Proposed refurbishment of bay window

4/5 mansion house
west boldon
ne 36 0QW

for mr. s. france.

PROPOSED.

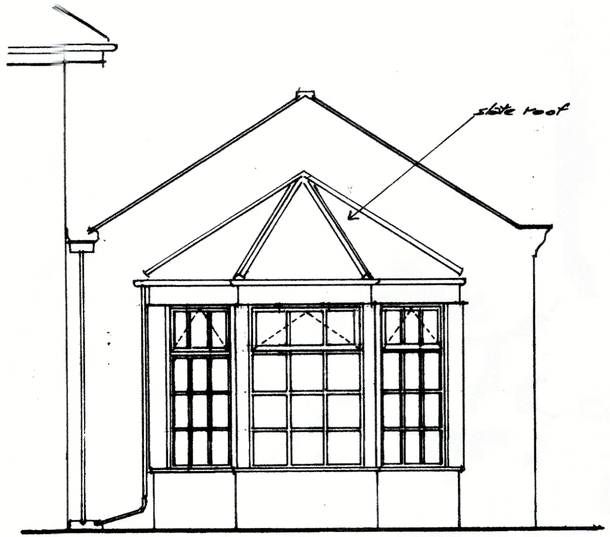
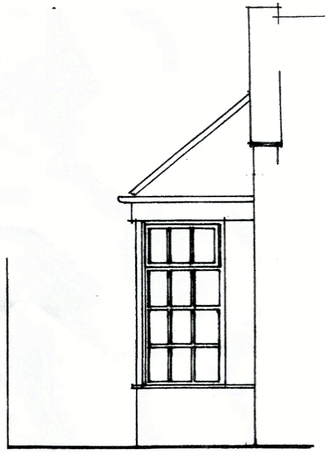
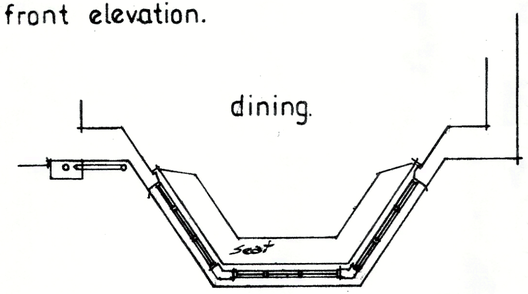
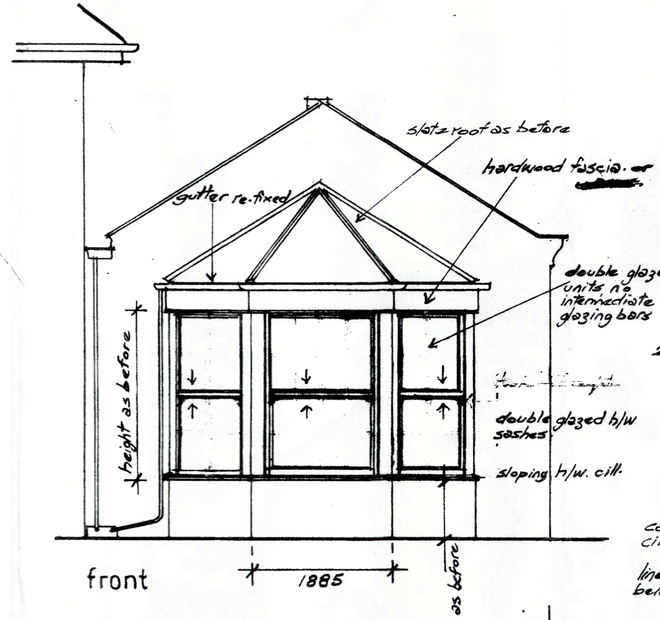
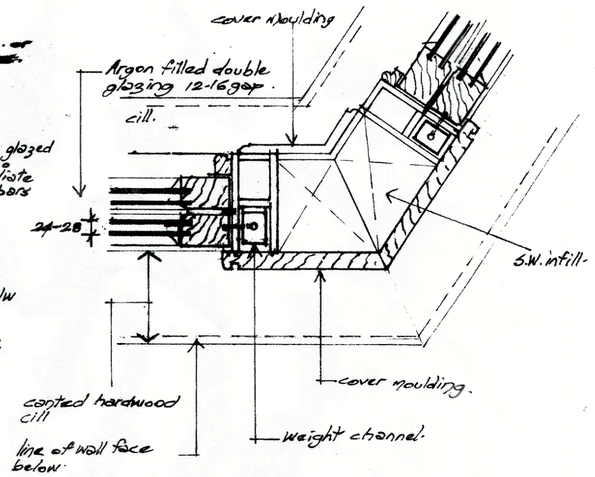
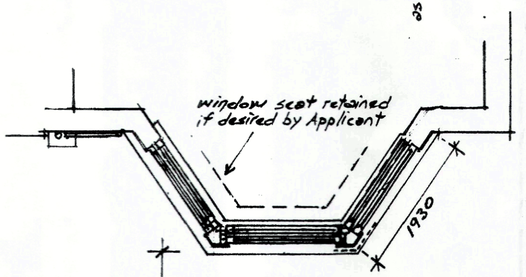
AMENDMENTS	
sliding sash, double glazed units in.	fascia to be hardwood
hardwood: 'sapele' favoured.	no 'horns' (or tusks) to be incorporated.
window 'furniture' to applicant's wishes	existing slates to be salvaged where possible
	new flashings to be code 4 lead coated in patination oil.
